## HISTORIC DISTRICTS REVIEW BOARD FIELD TRIP

## HISTORIC DISTRICTS REVIEW BOARD HEARING

**SUMMARY INDEX**  
**HISTORIC DISTRICTS REVIEW BOARD**  
May 27, 2014

**MINUTES OF THE**  
**CITY OF SANTA FÉ**  
**HISTORIC DISTRICTS REVIEW BOARD**

SHEET NO.  
**A-1**

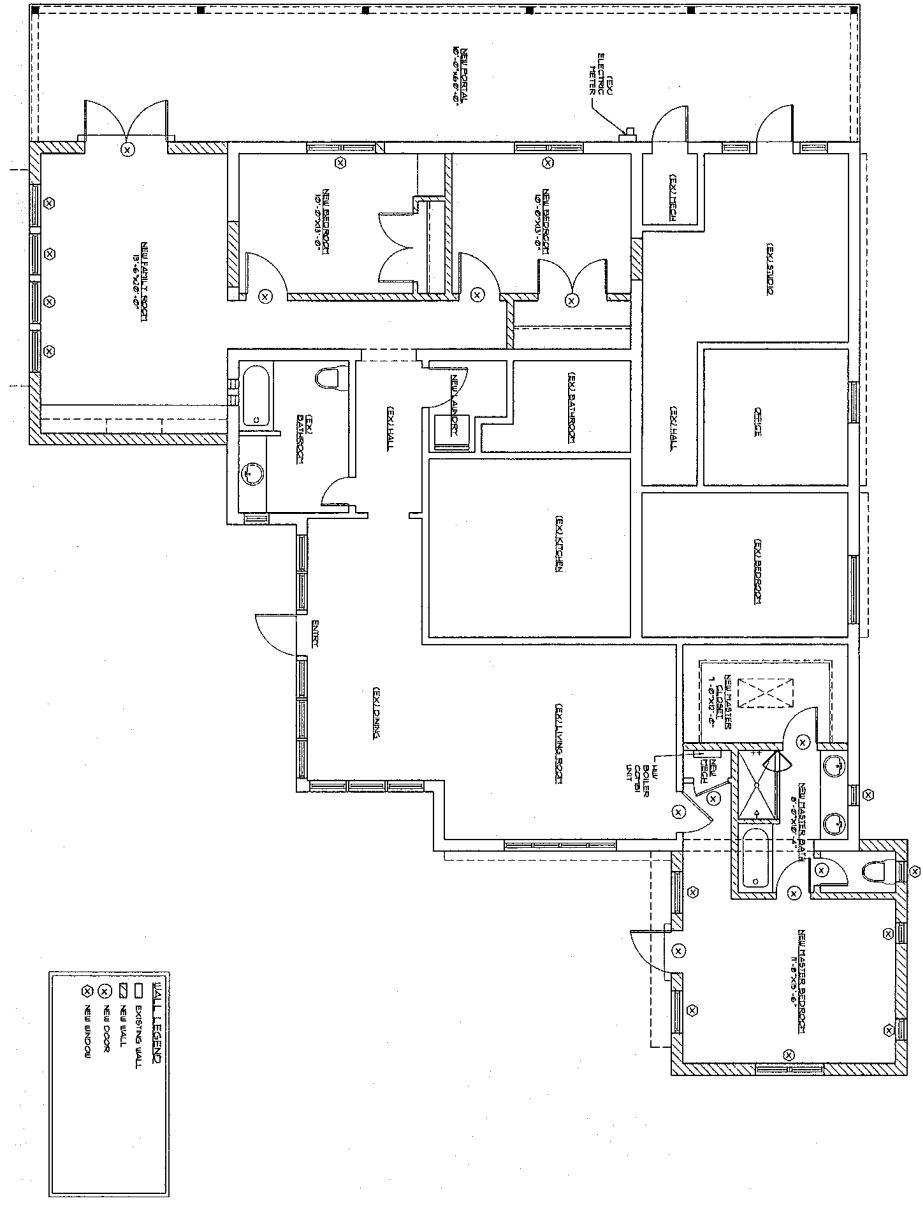
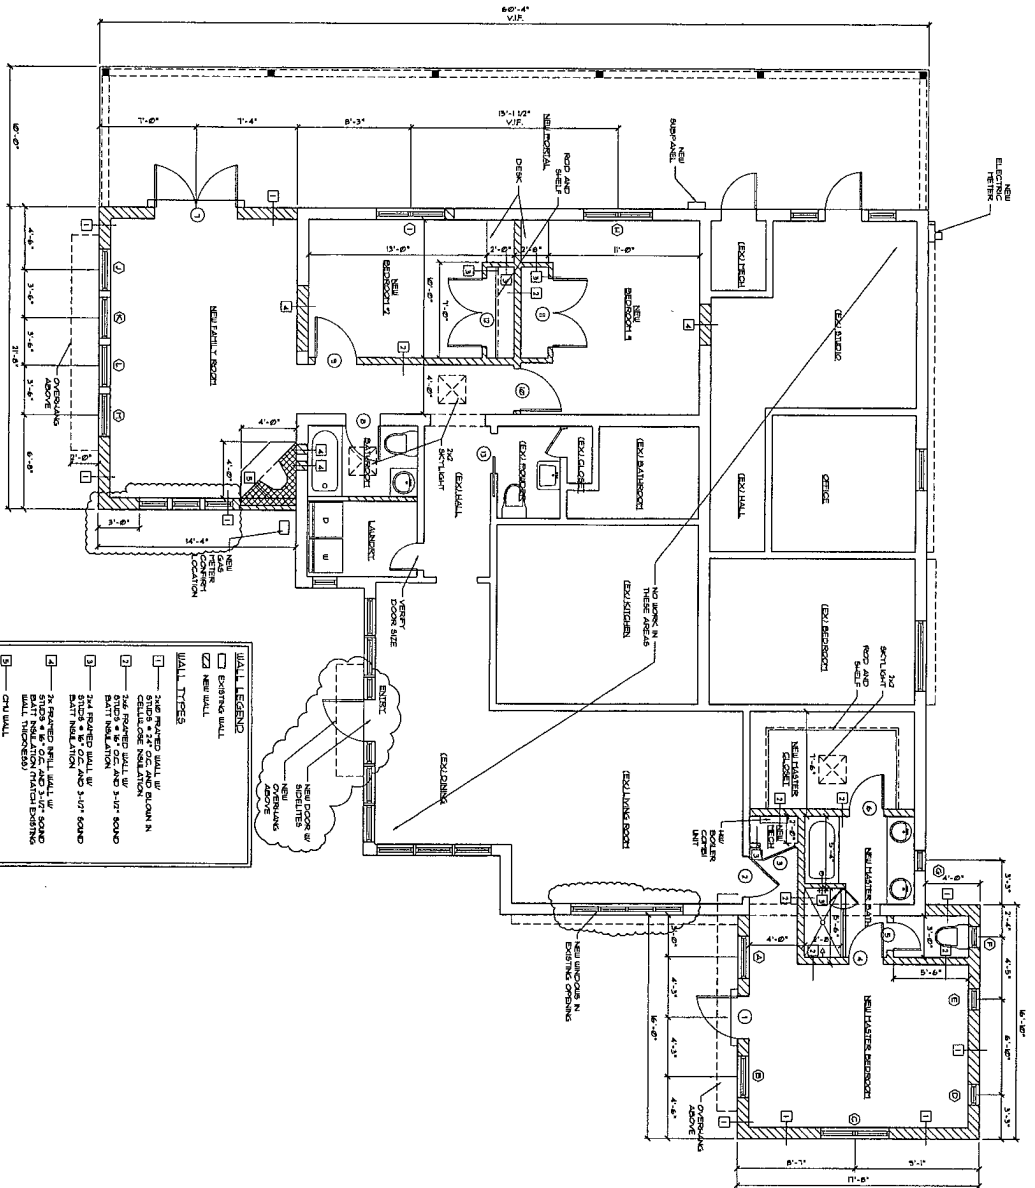
Mr. Roach said in the packet there was a change to the east elevation with the French door to replace the three windows on east elevation.
